## Town of Mammoth Lakes

### Planning & Economic Development Commission Staff Report

**AGENDA TITLE:** Consideration of Tentative Tract Map (TTM) 22-002, Use Permit (UPA) 22-001, and Major Design Review (DR) 22-001, for approval of the “Limelight Hotel” development project located at the northwest corner of Canyon Boulevard and Lake Mary Road (Mammoth Hillside site) in the “Plaza Resort” and “Specialty Lodging” zone of the North Village Specific Plan Area. Pursuant to the California Environmental Quality Act (CEQA) Guidelines, an Addendum to the 1999 Subsequent Program Environmental Impact Report (SPEIR) was prepared for the Limelight Hotel project.

**FIGURE 4 - NATURAL GRADE MEASUREMENTS AT PARKING GARAGE**

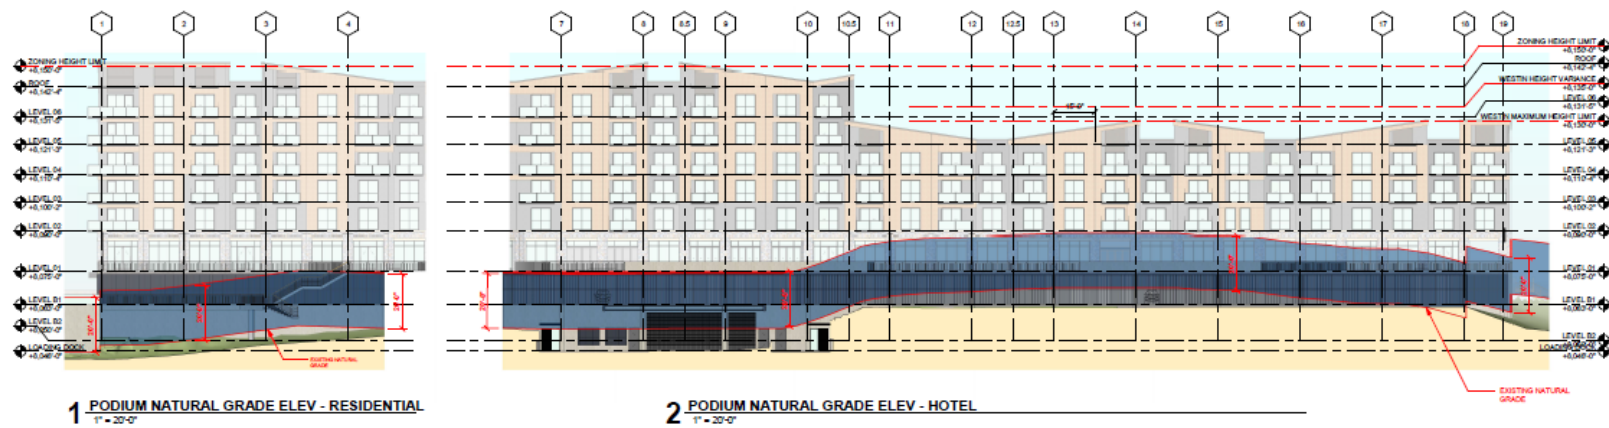
The tallest (southern) portion of the hotel structure is 75 feet in height, measured from the garage roof elevation at the perimeter of the building. This building height excludes the height of the parking garage because the applicable building height standard in the North Village Specific Plan (NVSP Section 5. *Building Heights*) excludes the height of the parking podium (up to a maximum of 20 feet) when all or a portion of the building sits above a parking garage.

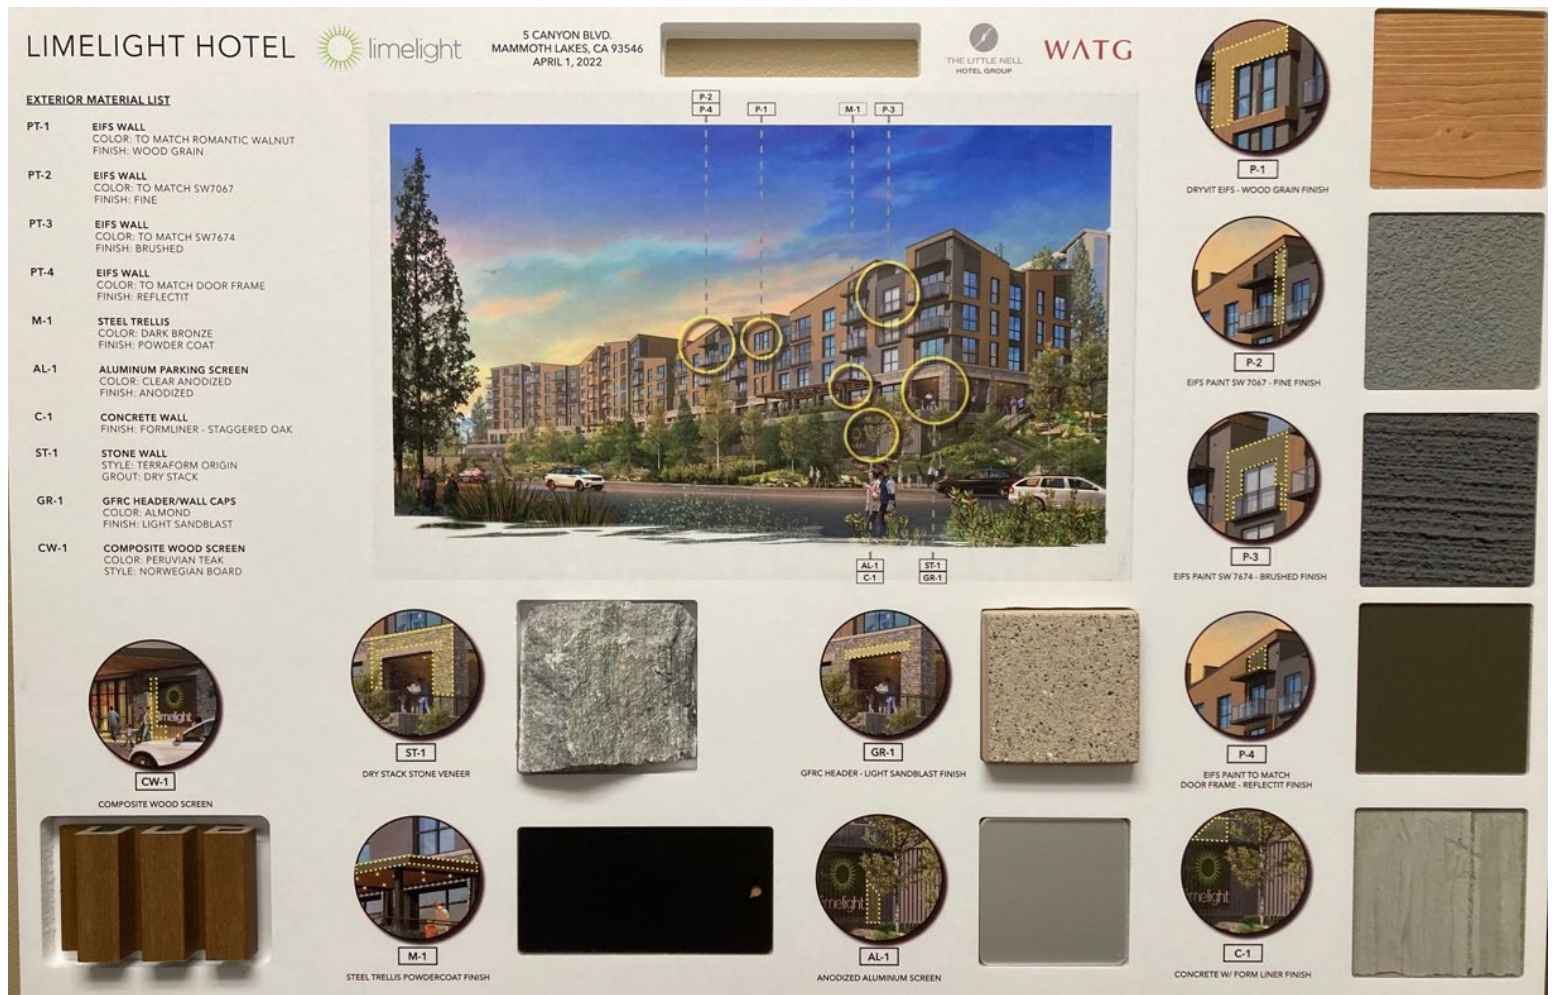
The exterior colors and materials were submitted in a digital format for review by the Advisory Design Panel. Digital renderings along with the proposed colors and materials we provided with pictures, rather than physical samples due in part, because public meetings were being held virtually. Once physical color and material samples were received by Town staff on April 11<sup>th</sup> (shown below), staff determined that two of the proposed materials/colors do not provide the same appearance of the color or material that was reviewed digitally. These colors and materials should be modified to meet the intent of the North Village Design Guidelines and ADP

recommendations. Staff suggests that the following conditions of approval be included for the project to ensure the design is consistent with the NVSP Design Standards and ADP recommendations:

- The color and finish for the “Anodized Aluminum Screen” surrounding visible portions of the parking garage should be changed to a darker color such as dark bronze and shall have a non-reflective finish.
- The color of the proposed “DRYVIT EIFS – Wood Grain Finish” siding material shall be changed to another wood grain finish that is darker and has less orange/peach tone.
- The applicant should provide a 3’ by 3’ foot mock-up of the proposed stone material and installation.
- The applicant should provide a more detailed elevation for the design of the retaining wall located at the corner of Canyon Boulevard and Lake Mary Road to ensure the design adequately diminishes the overall height of the wall.
- The applicant should provide the proposed gate or roll-up door design for the service entrance portal off Canyon Boulevard.
